**ELECTRONIC AGENDA PACKET FOR
THE PUBLIC HEARING OF
MONDAY, APRIL 11, 2022
7:00 P.M.***

PUBLIC HEARING AGENDA OF THE LIVONIA CITY COUNCIL
Monday, April 11, 2022
7:00 P.M.
Livonia City Hall Auditorium
33000 Civic Center Drive, Livonia, Michigan

Petition 2003-08-SN-08 submitted by Aver Sign Company requesting to amend Council Resolution #549-03, adopted by the Livonia City Council on October 22, 2003, to allow the illumination of tubing around the pump island canopy of the BP gas station at 27428 Schoolcraft Road, located on the northwest corner of Schoolcraft and Inkster Roads in the southeast ¼ of Section 24.

Petition 2021-11-08-06 submitted by Jeffery Scott Architects requesting approval of all plans required by Section 13.13 of the Livonia Vision 21 Zoning Ordinance, in connection with a proposal to remodel the exterior facade and modify the approved landscape plan of the commercial strip center at 16112 thru 16184 Middlebelt Road, located on the east side of Middlebelt Road between Five Mile Road and Terrence Avenue in the Northwest ¼ of Section 13.

SPA-1

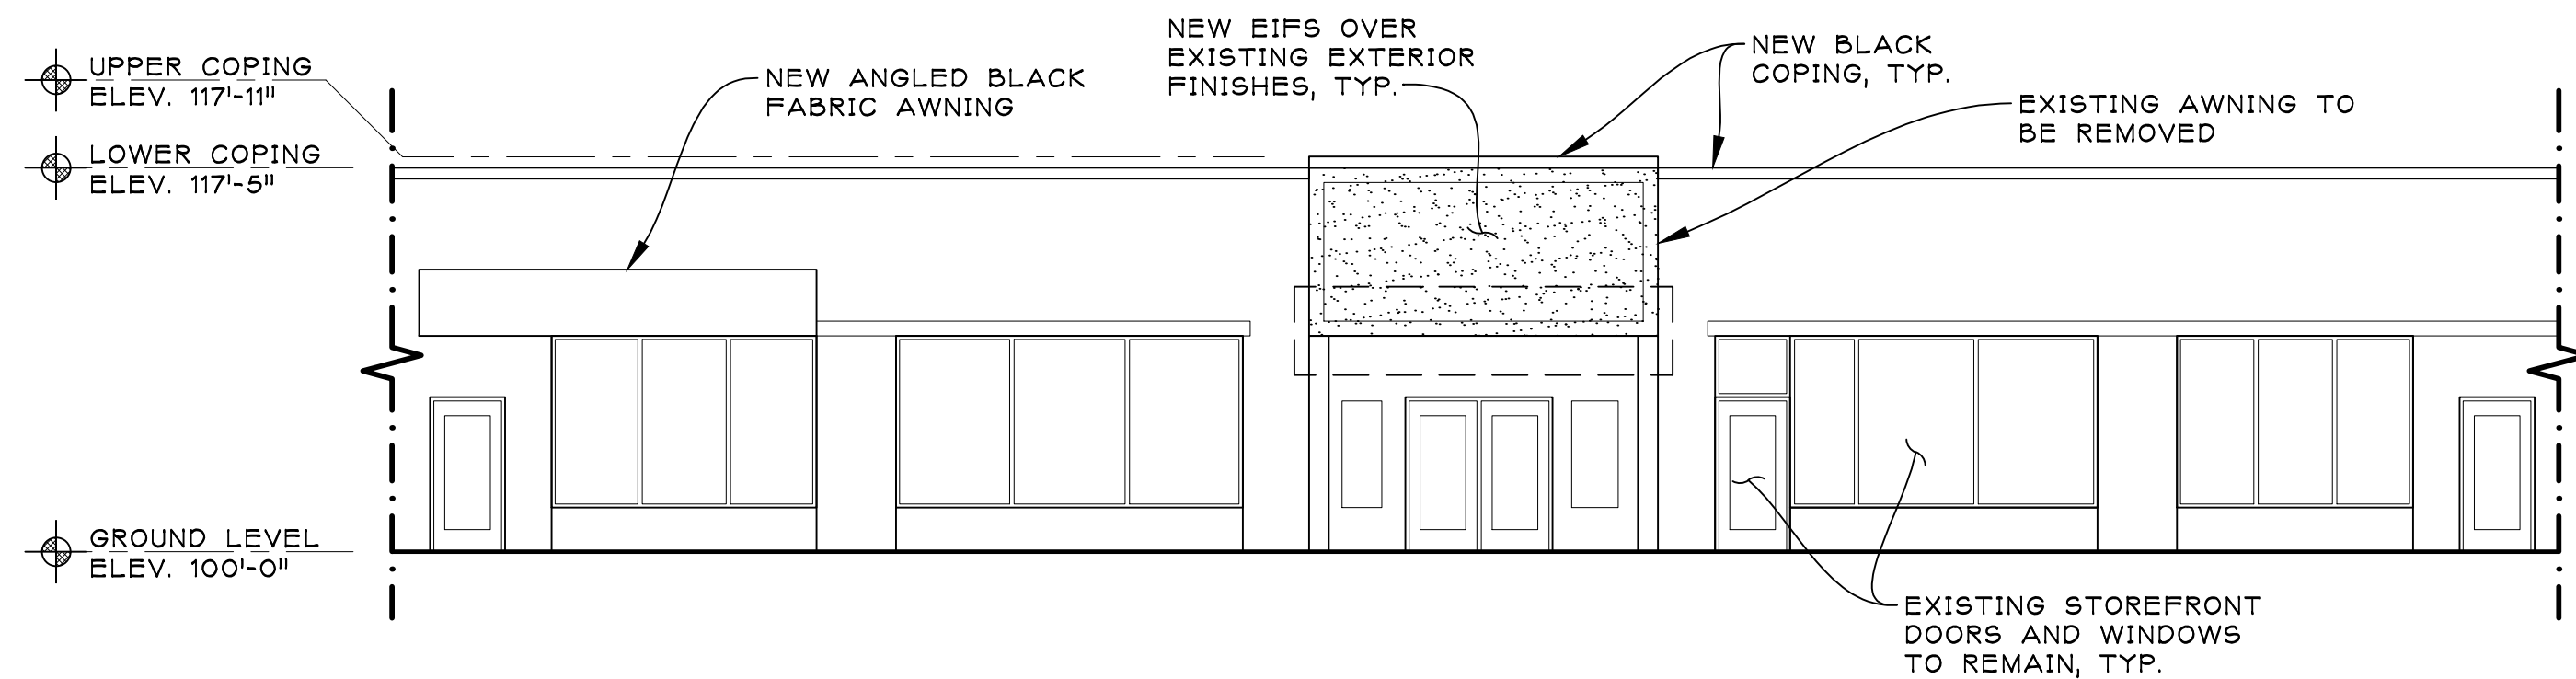
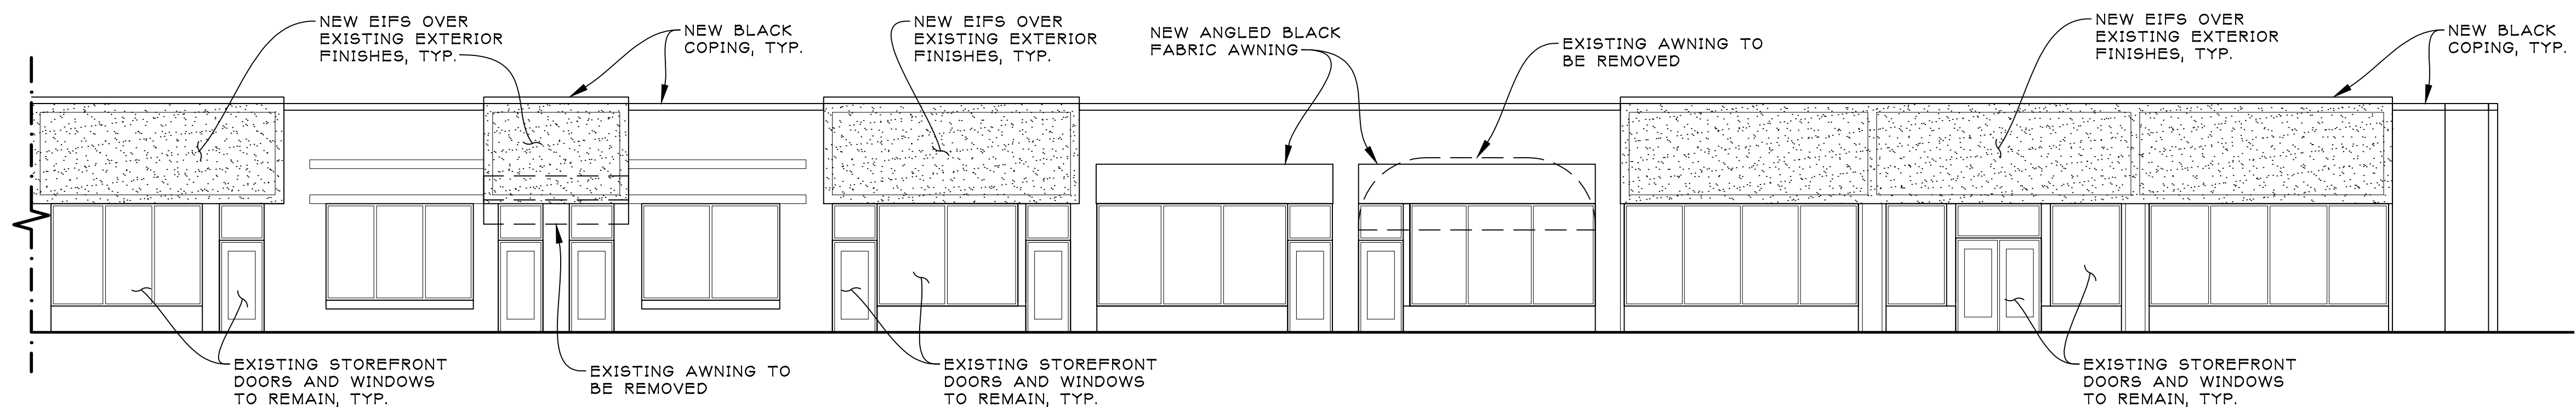
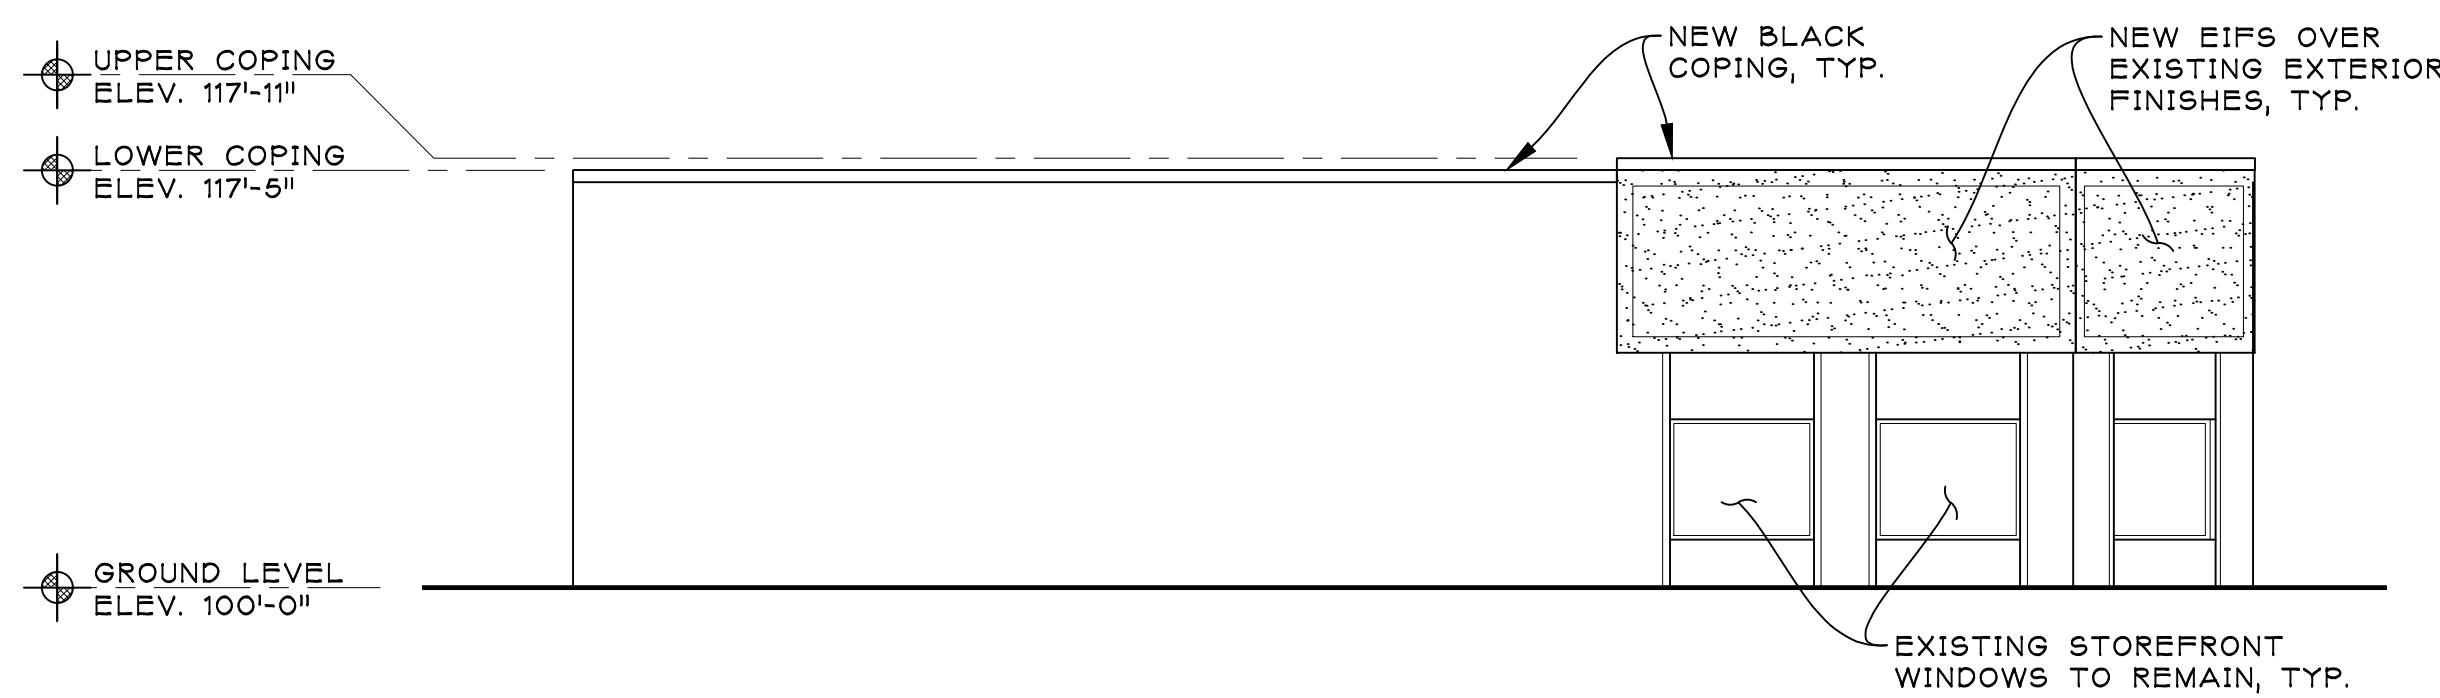
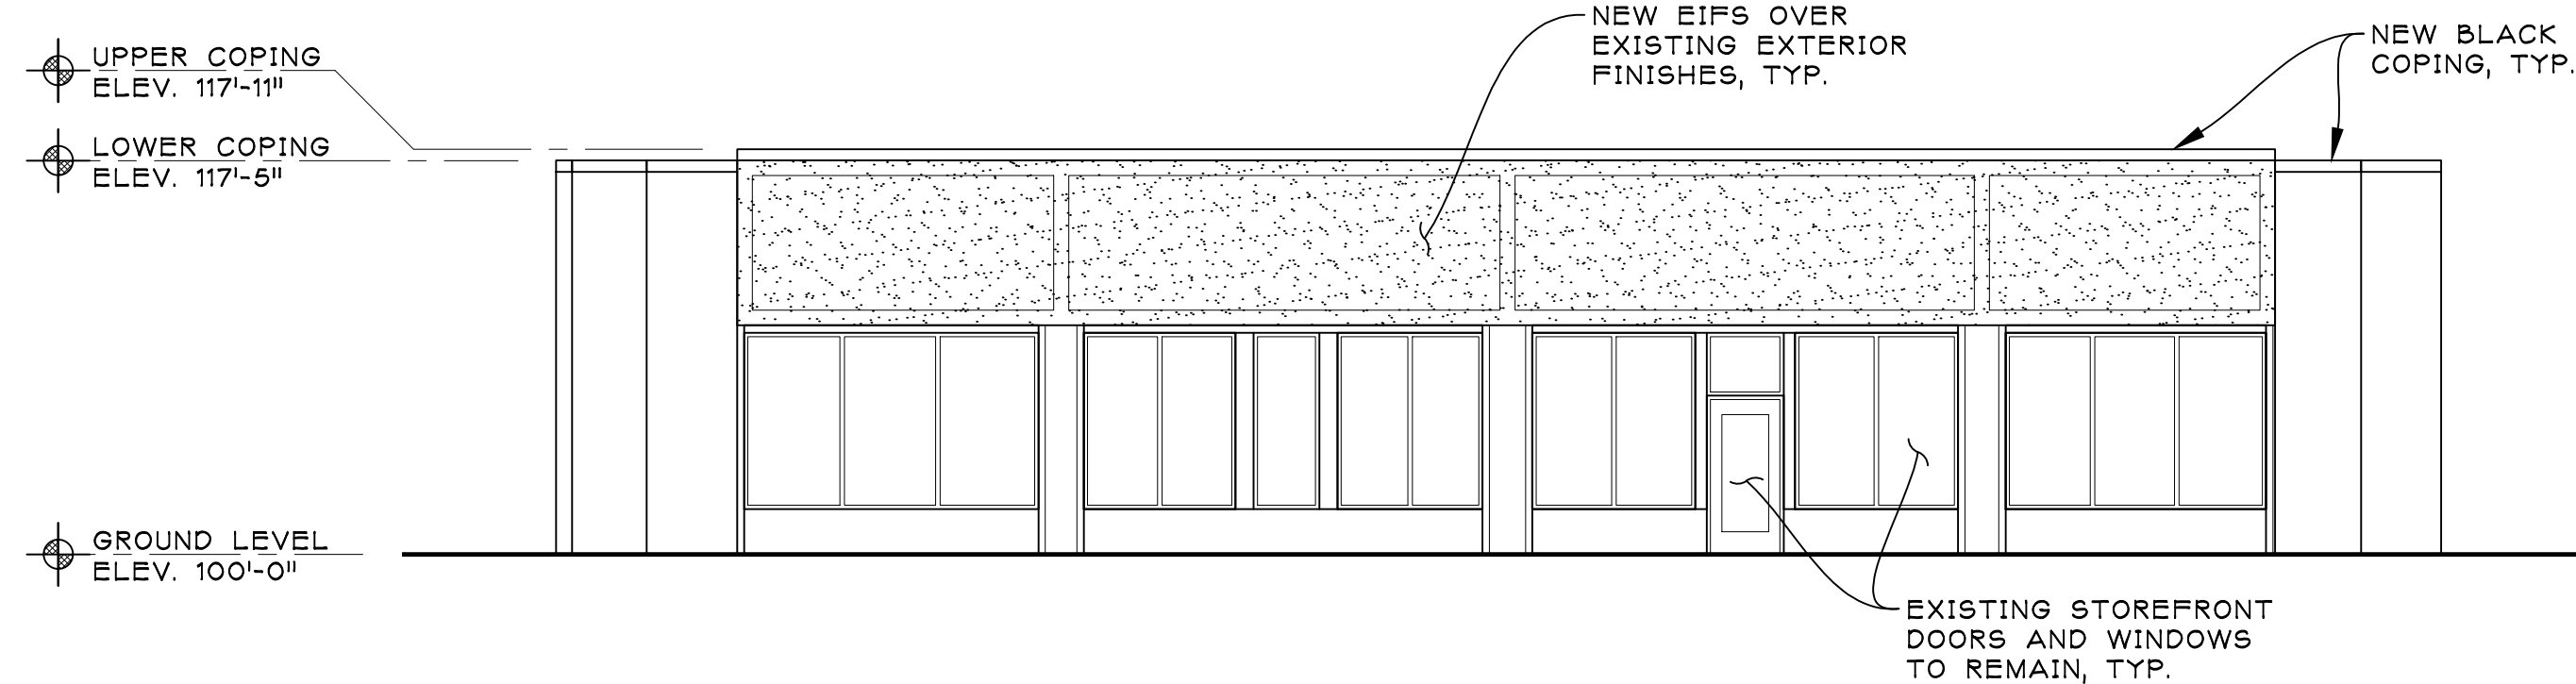
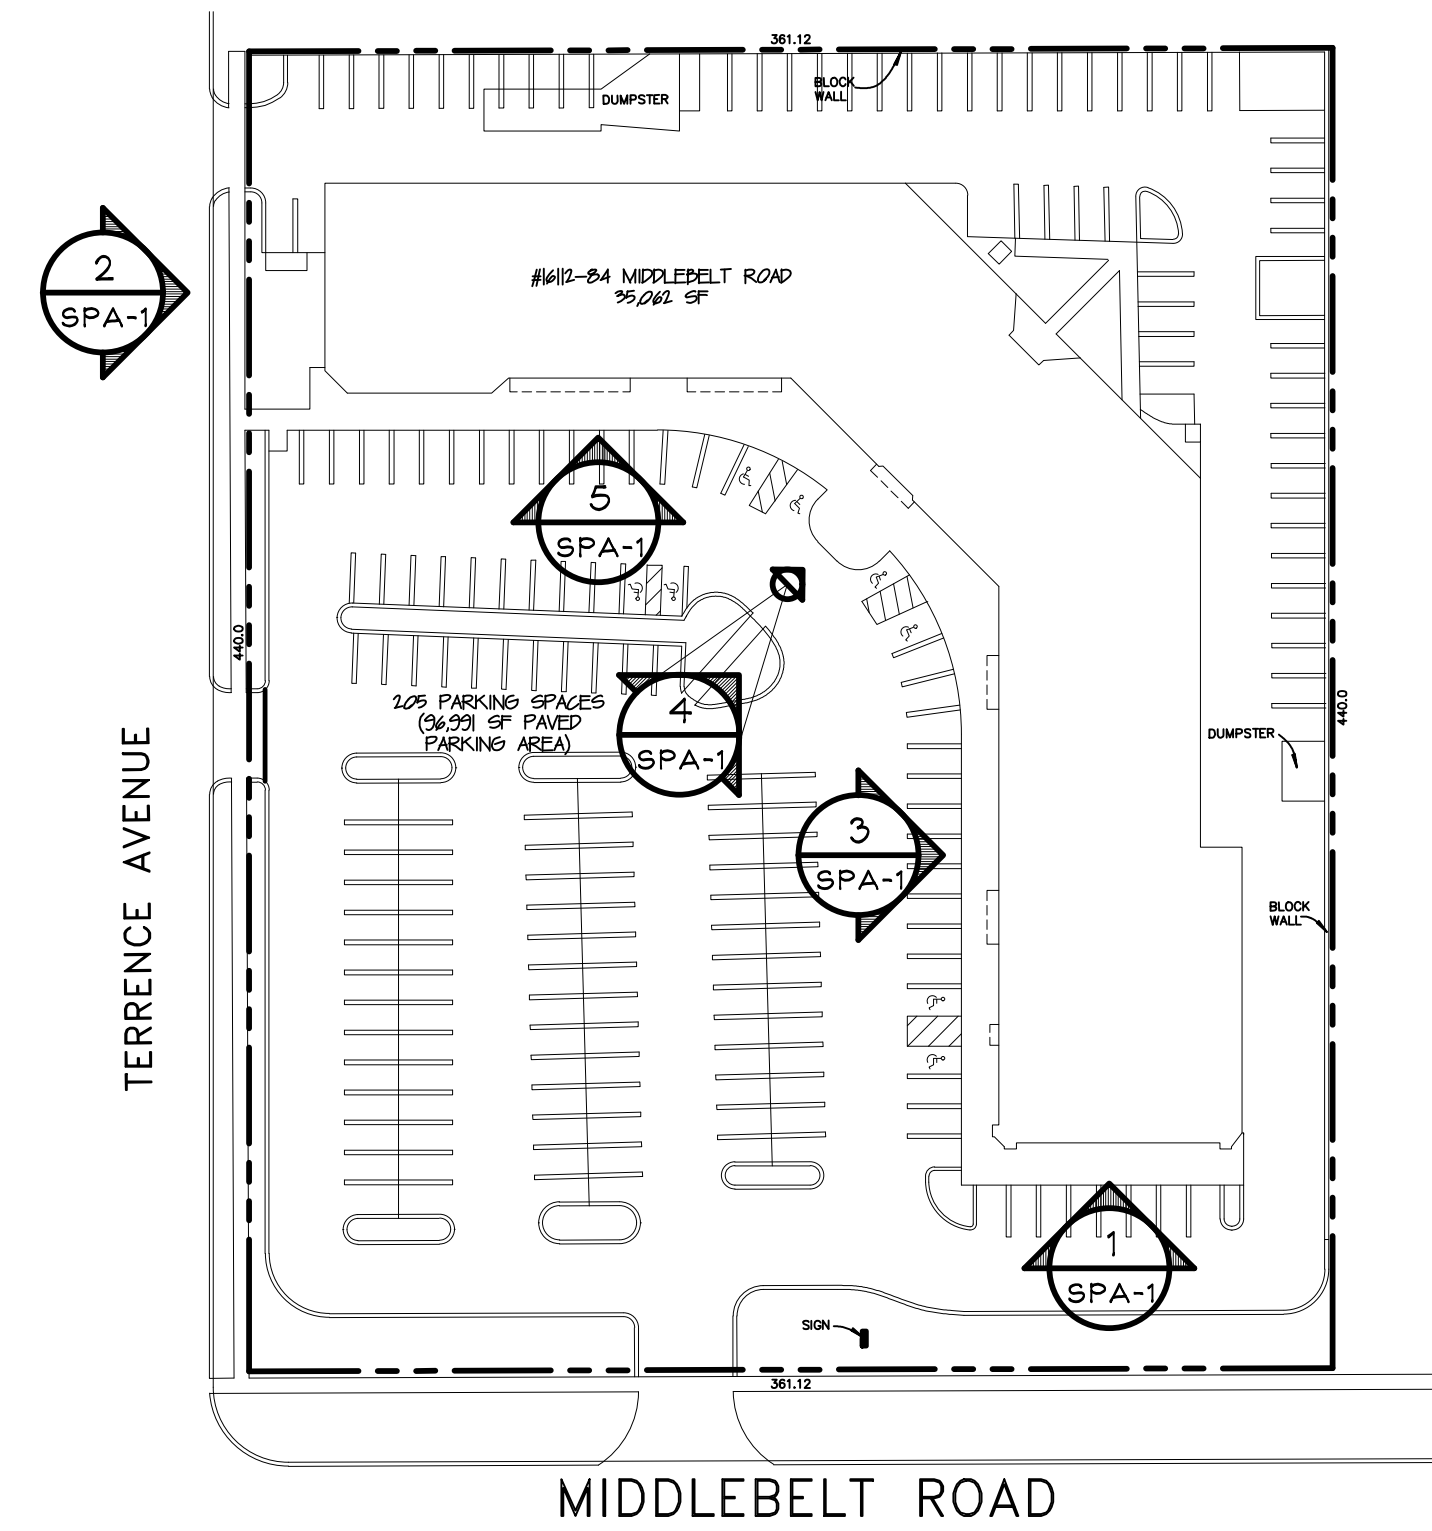
1. That the Exterior Elevations Plan identified as Sheet No. SPA-1, dated September 17, 2021, prepared by Jeffery A. Scott Architects, is hereby approved and shall be adhered to.

5. That no LED light band or exposed neon shall be permitted on this site including, but not limited to, the building or around the windows.
6. That the specific plans referenced in this approving resolution shall be submitted to the Inspection Department at the time the building permits are applied for; and
